**SUBJECT: Final Remedial Design Work Plan for the Ash Landfill Operable Unit and Draft Final Construction Completion Report for SEAD-25 and SEAD-26 at Seneca Army Depot Activity; Contract FA8903-04-D-8675, Delivery Order 0012, CDRL A001B, A001C, and A004**

**SUBJECT: Final Remedial Design Work Plan for the Ash Landfill Operable Unit and Draft Final Construction Completion Report for SEAD-25 and SEAD-26 at Seneca Army Depot Activity; EPA Site ID: NY0213820830 - NY Site ID: 8-50-006;**

CLIENT/PROJECT TITLE  
**SENECA ARMY DEPOT**  
 ROMULUS, NEW YORK  
 SEAD 25/26 CONSTRUCTION COMPLETION REPORT

C-1  
TITLE SHEET

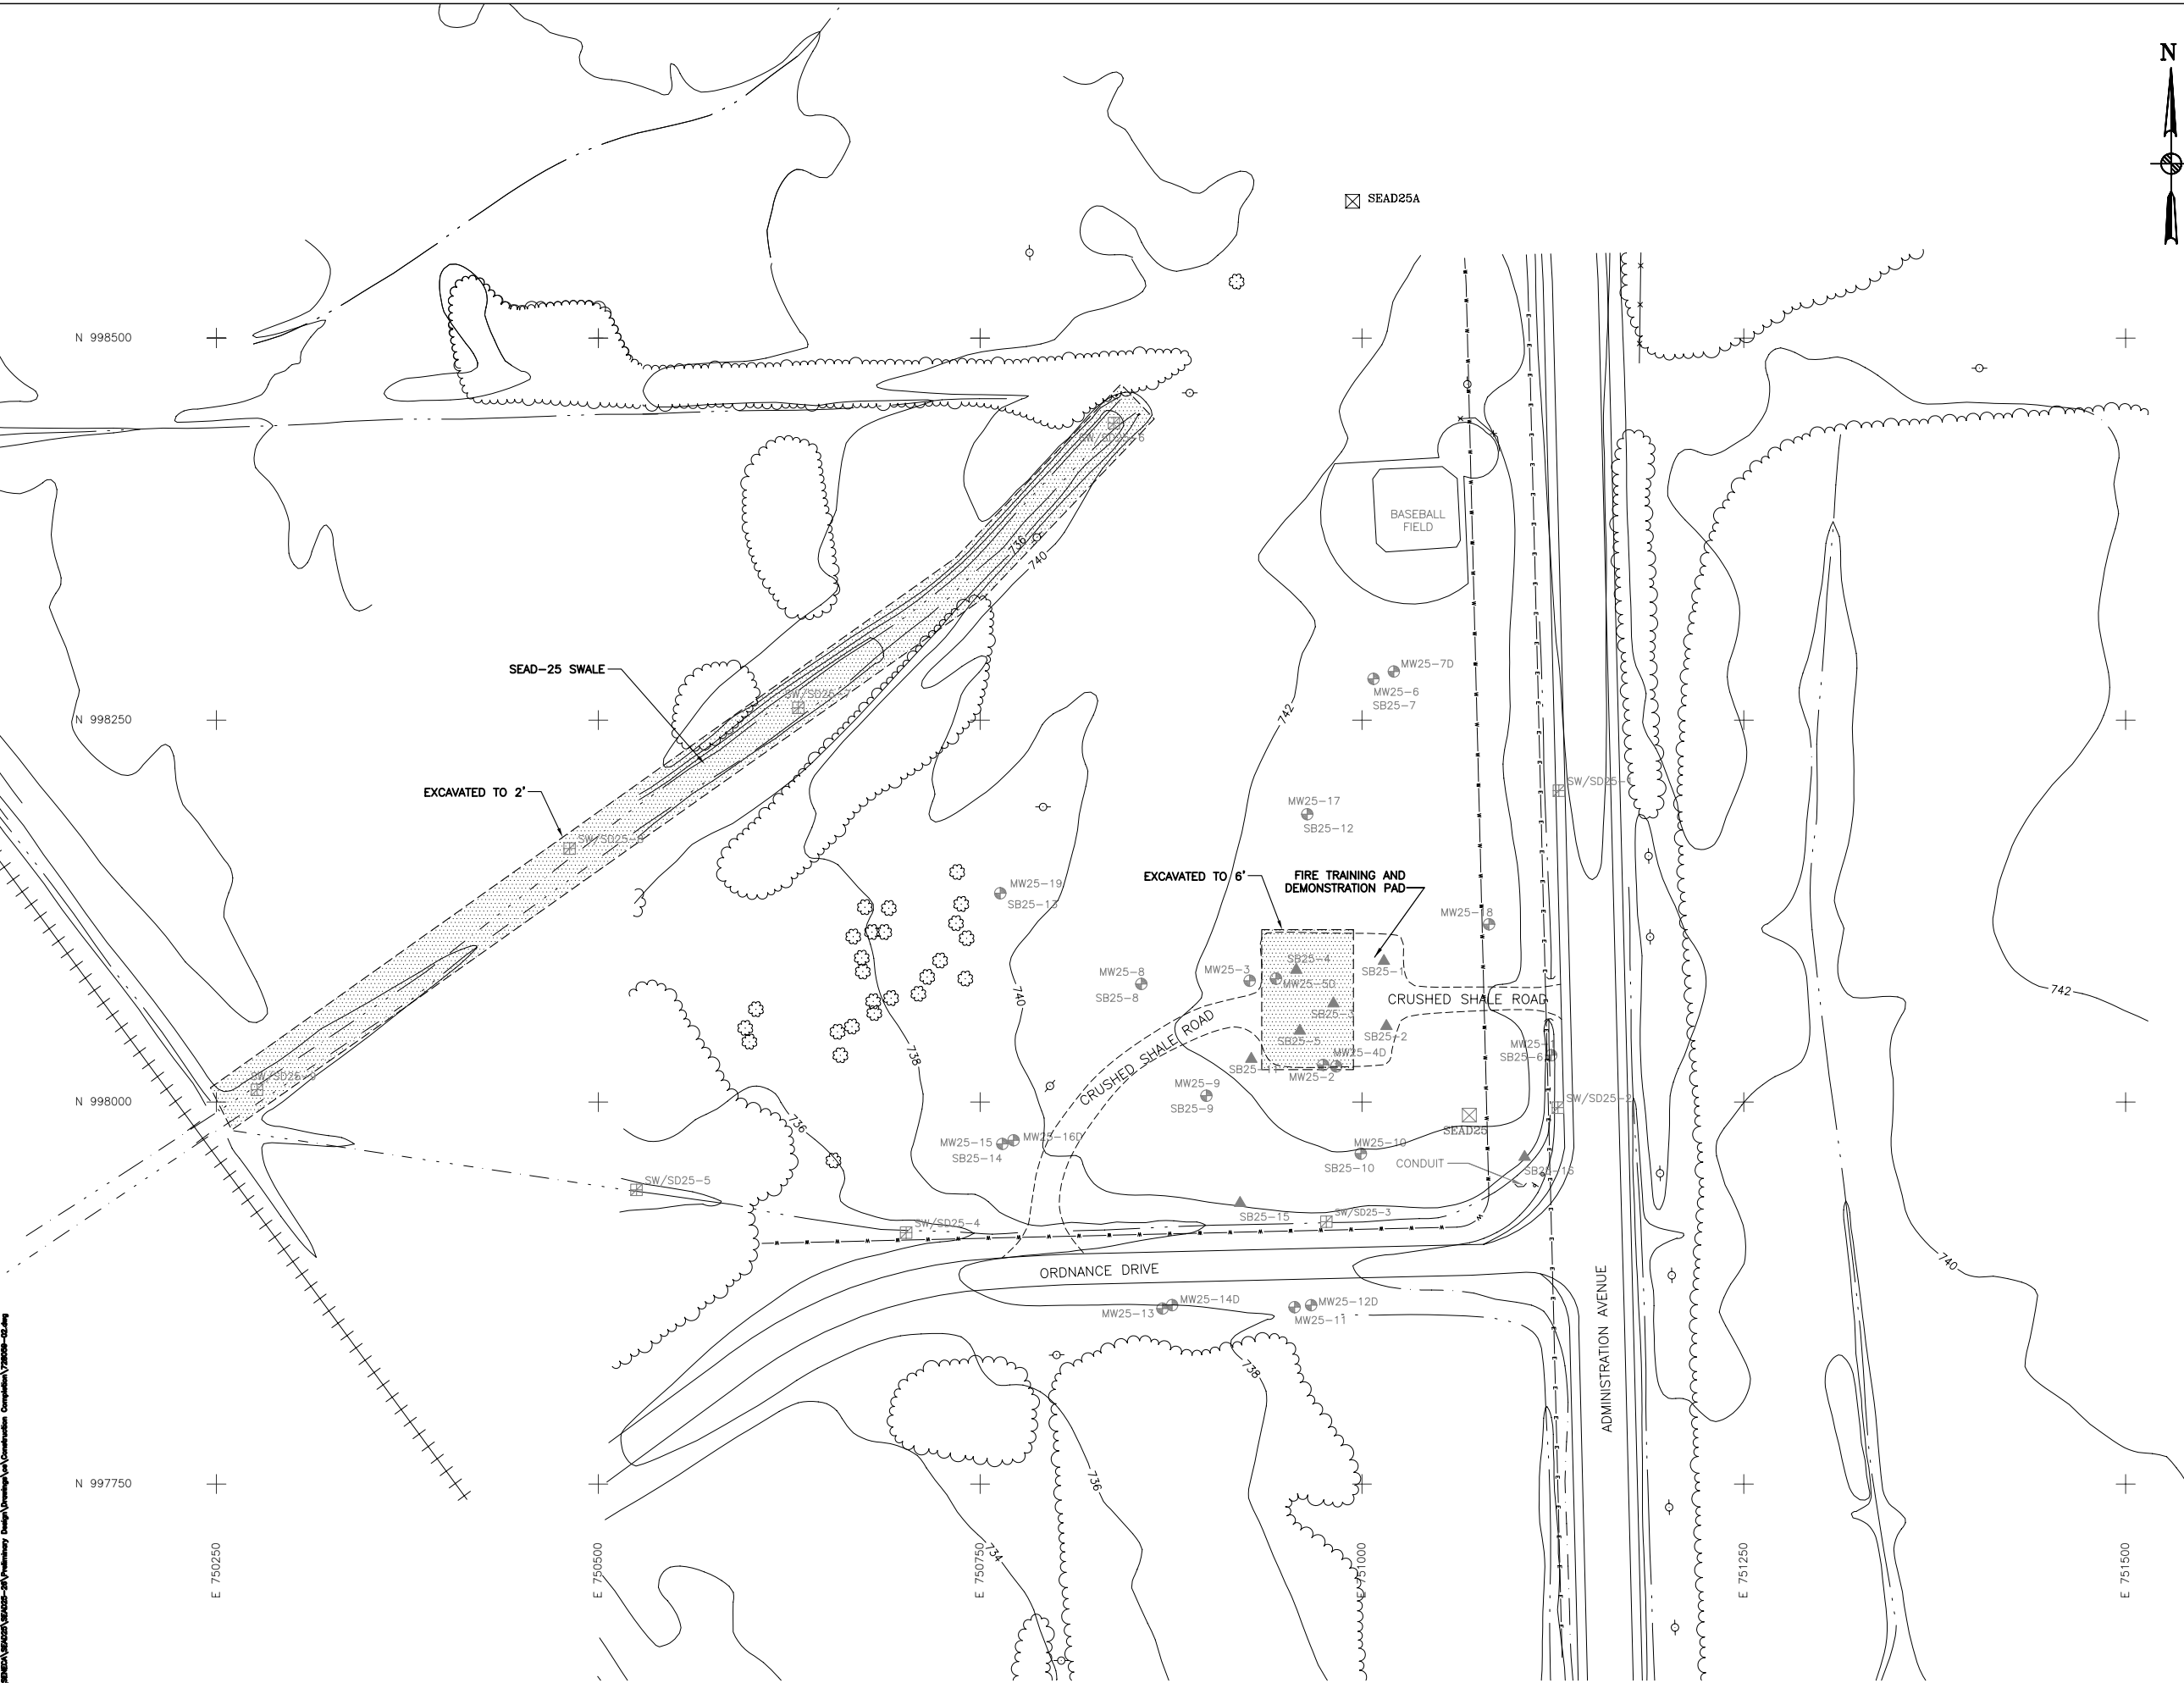
**Comment 2: Drawing C-1, "Title Sheet."** This map does not show NY State 96A as stated on page 1-2.
